# ILC Interaction Region Configuration Change Request

LCWS14, Belgrade  
Karsten Buesser  
09.10.2014

<b>CHANGE REQUEST NO. ILC-CR-000N</b>	EDMS No: <b>D0000000xxxxxxx</b>	Created: <b>16-09-2014</b>
		Last modified: <b>24-09-2014</b>

## **DETECTOR HALL WITH VERTICAL SHAFT ACCESS**

# Hybrid-A' General layout

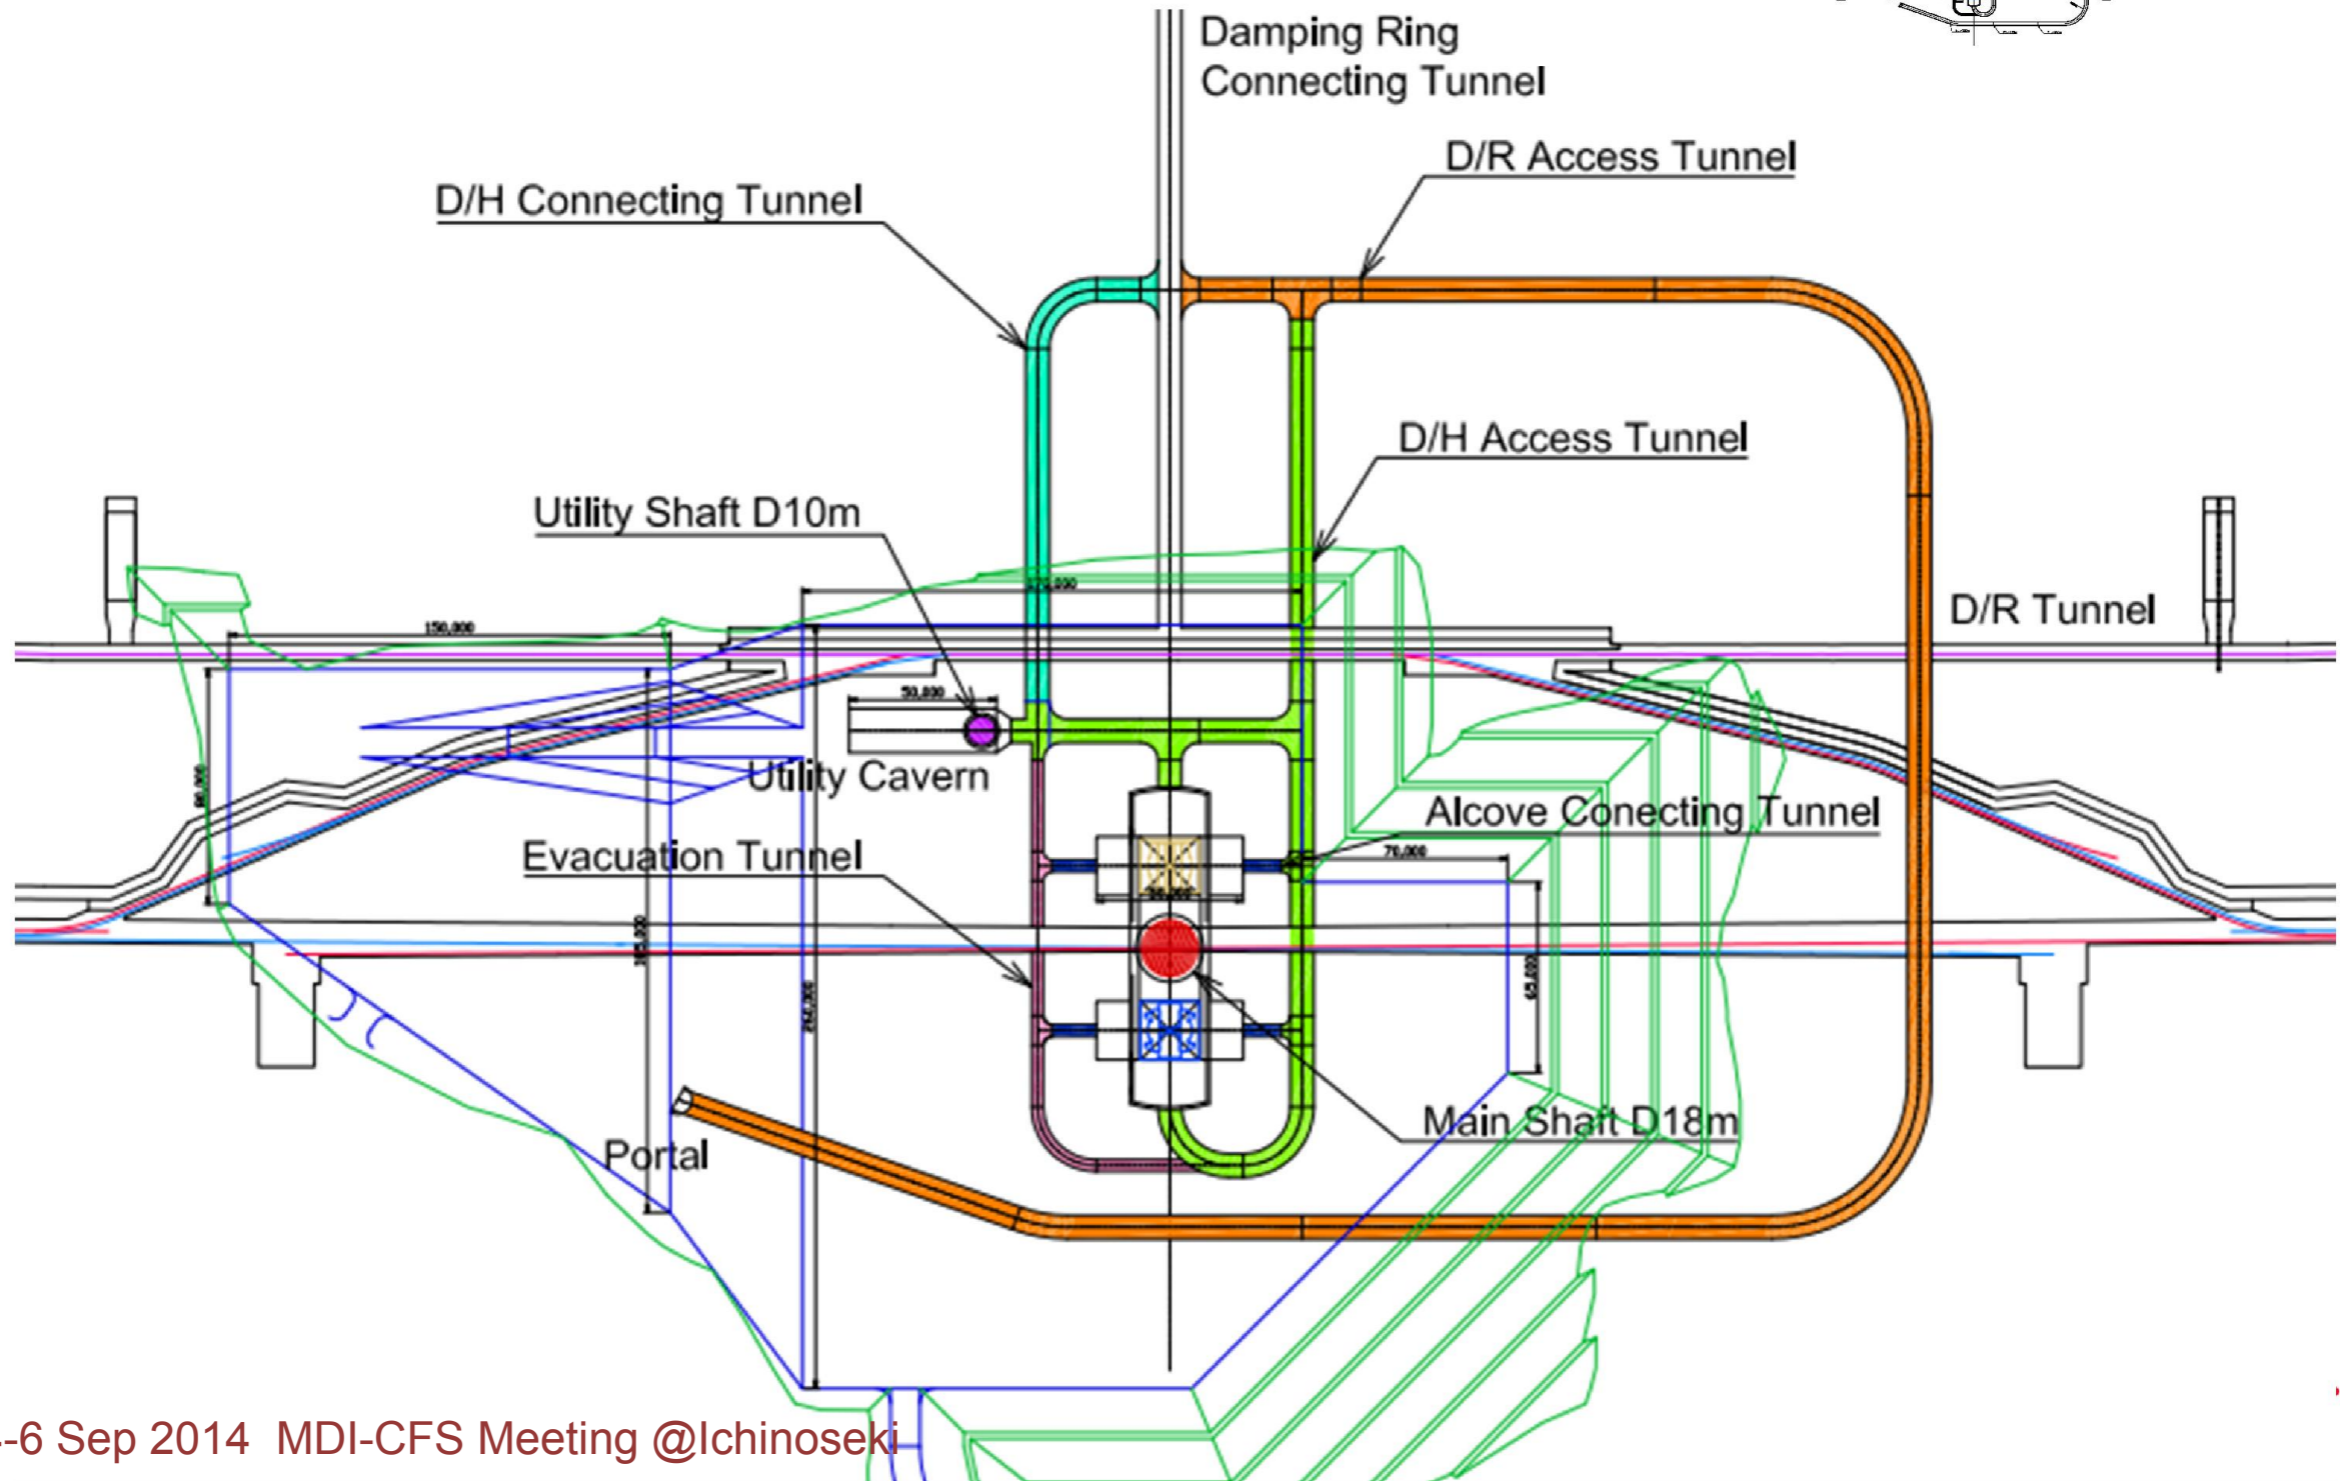
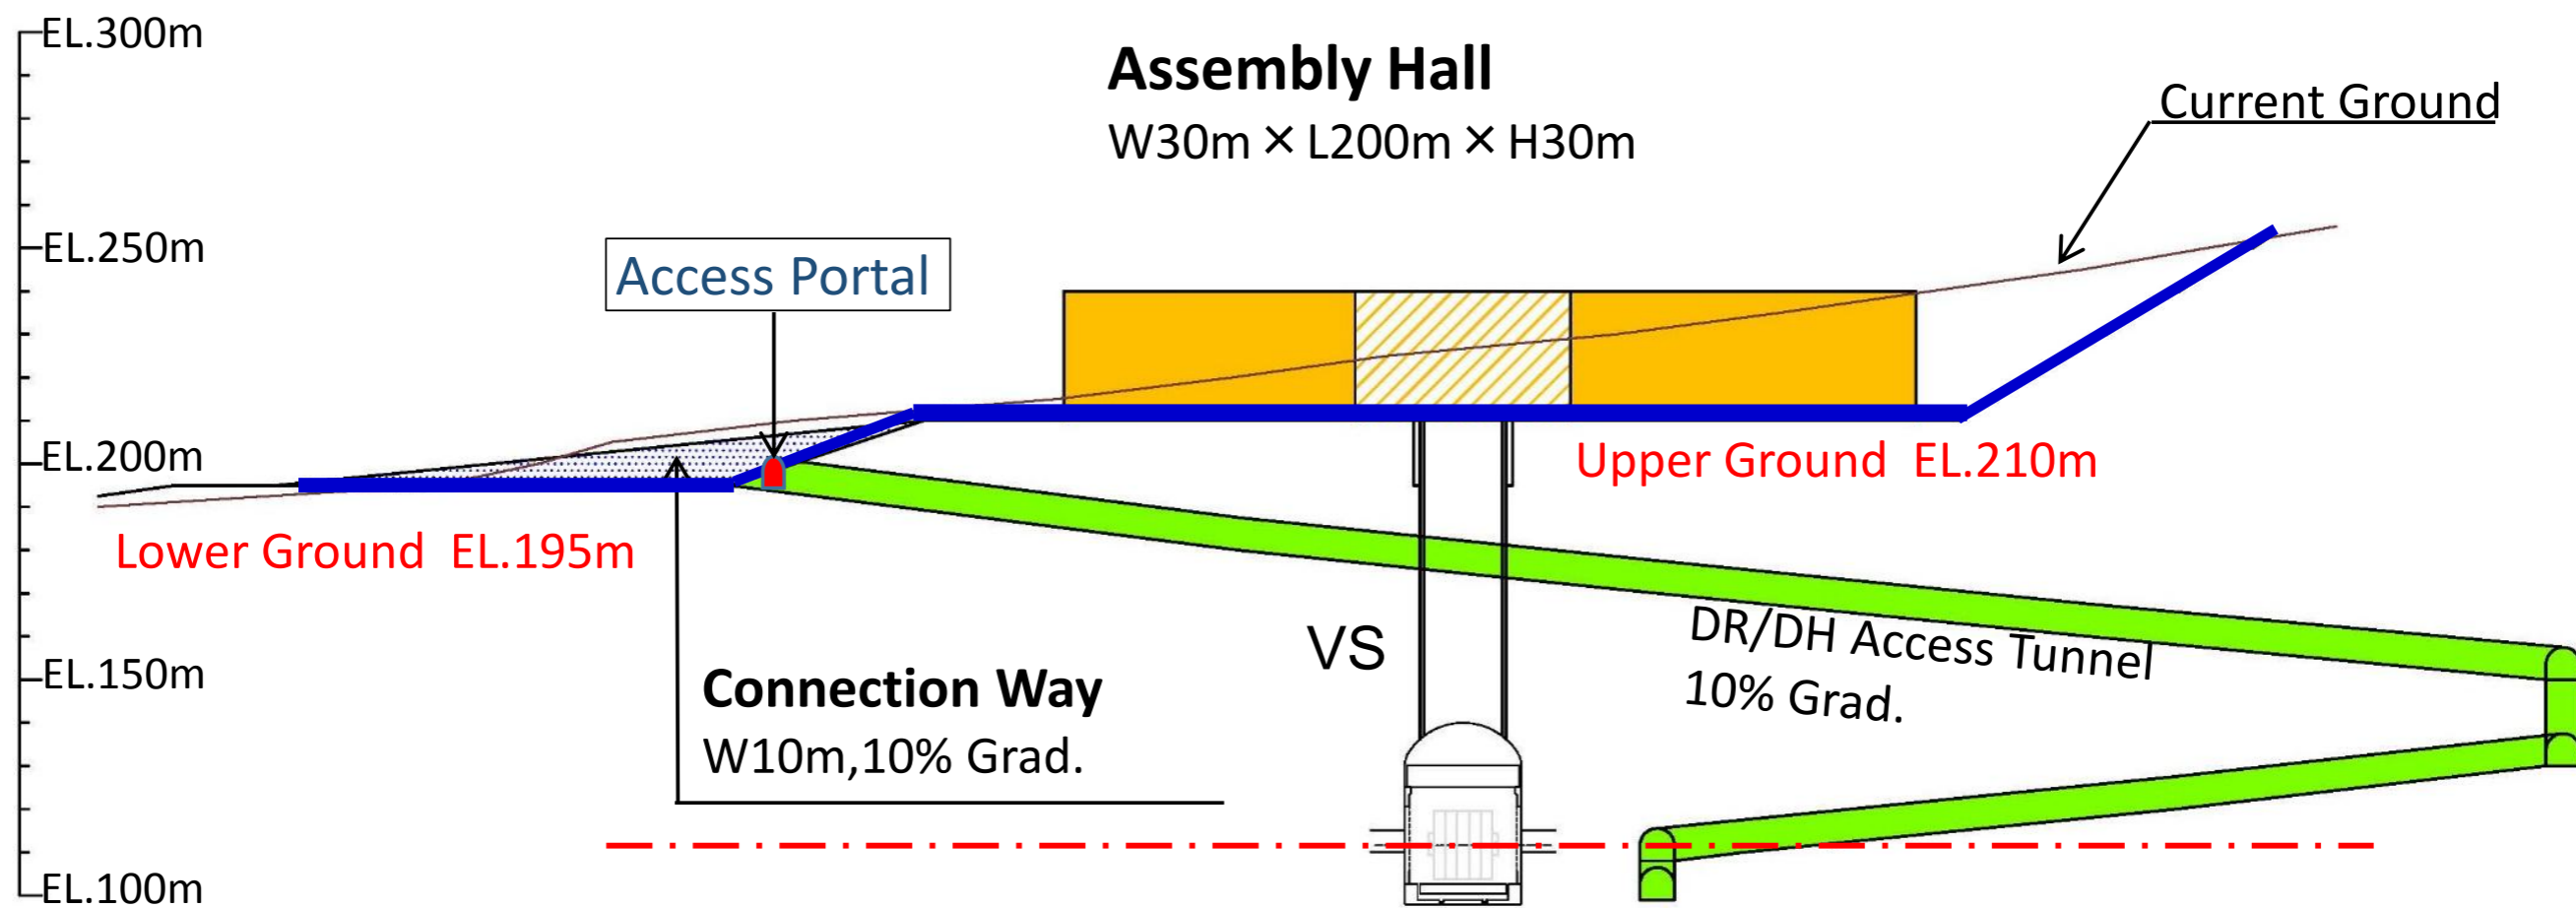
Change the underground experimental hall to a design that has a large vertical shaft and allows for the “CMS style” assembly of the detectors.

The baseline (TDR) design of the interaction region (IR) for the ILC in Japan foresees an underground experimental hall that can be accessed only via a horizontal O(1km) long tunnel of ~11m width and a slope of O(7%). This has been defined before the Kitakami site has been selected for the ILC in Japan under the assumption that any Japanese site would be in a mountainous area that does not allow to have an assembly and maintenance area directly on top of the underground IR. The Kitakami site, however, allows to find a position for the IR that has a reasonably flat area above the IR and where a vertical shaft of O(70m) length could be built to access the underground areas.

# Hybrid-A' Shafts

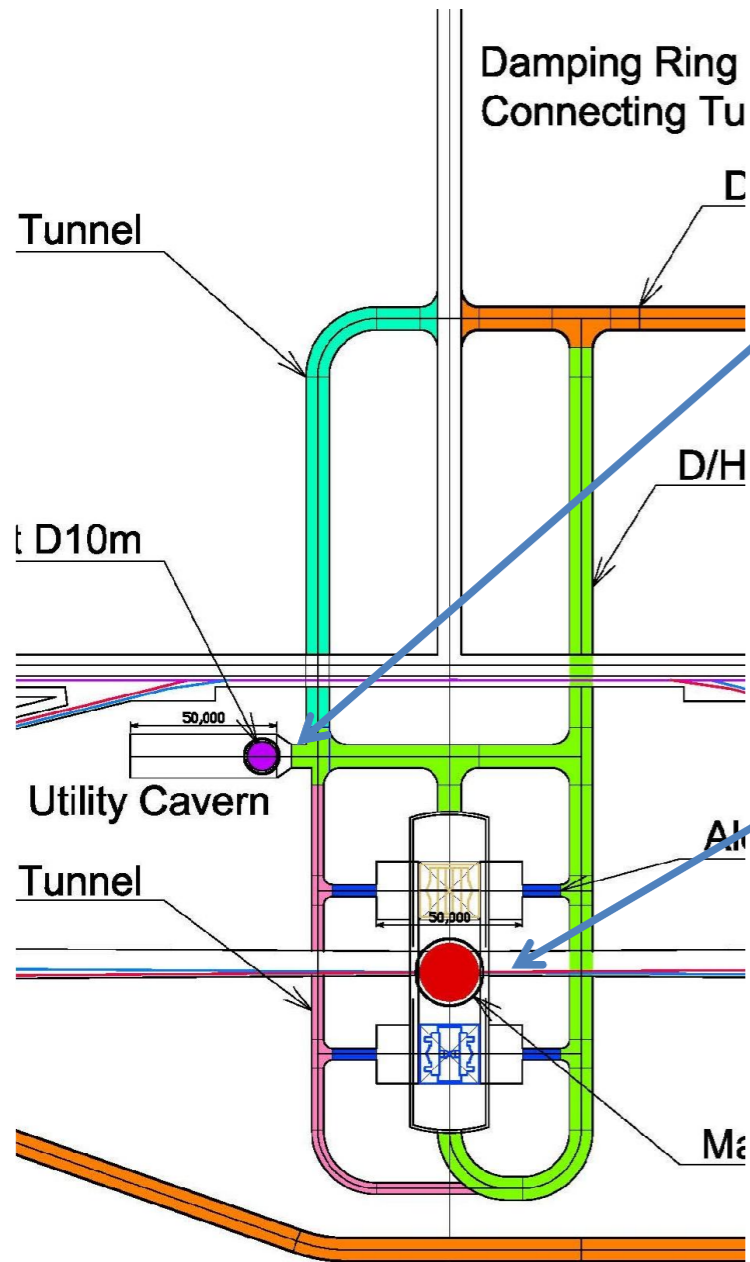
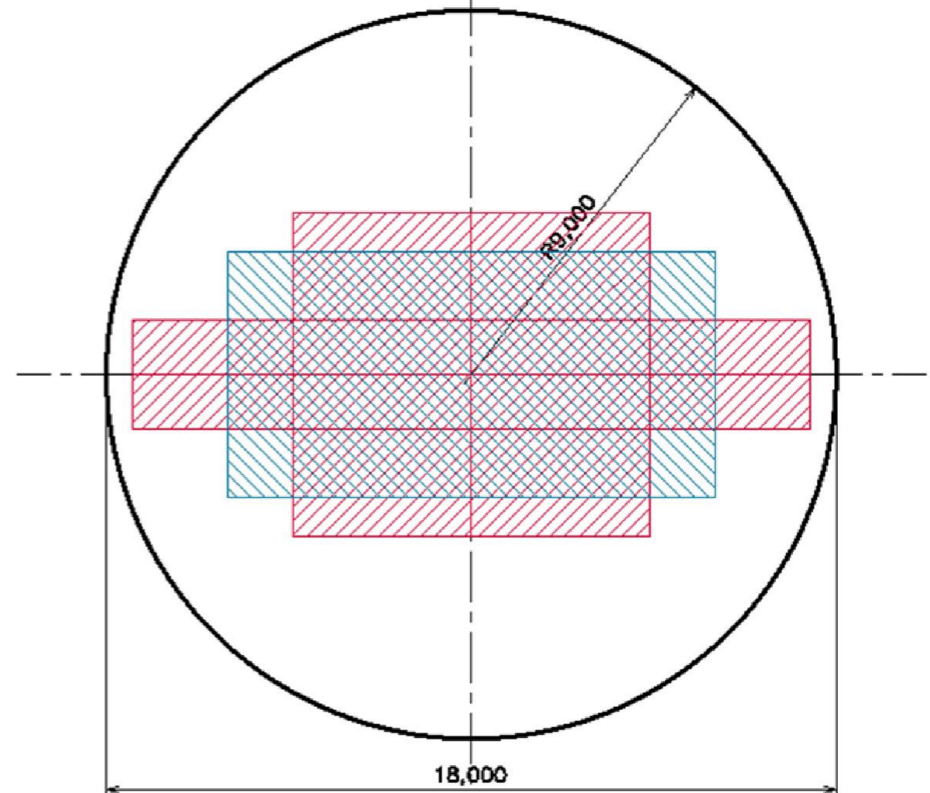
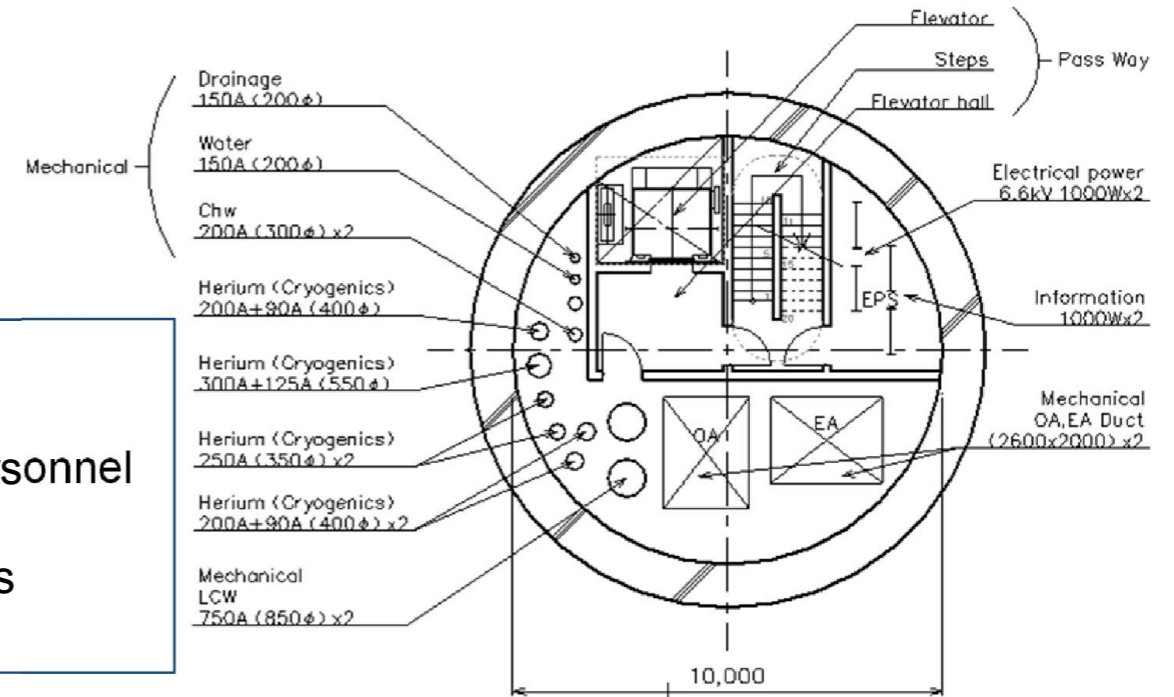
Utility shaft D=10m  
 Utility cavern  
 Utility lines and Personnel access to D/H  
 Pipes, ducts, cables  
 Elevator and stair

Main shaft D=18m  
 Center of DH  
 Detectors Installation
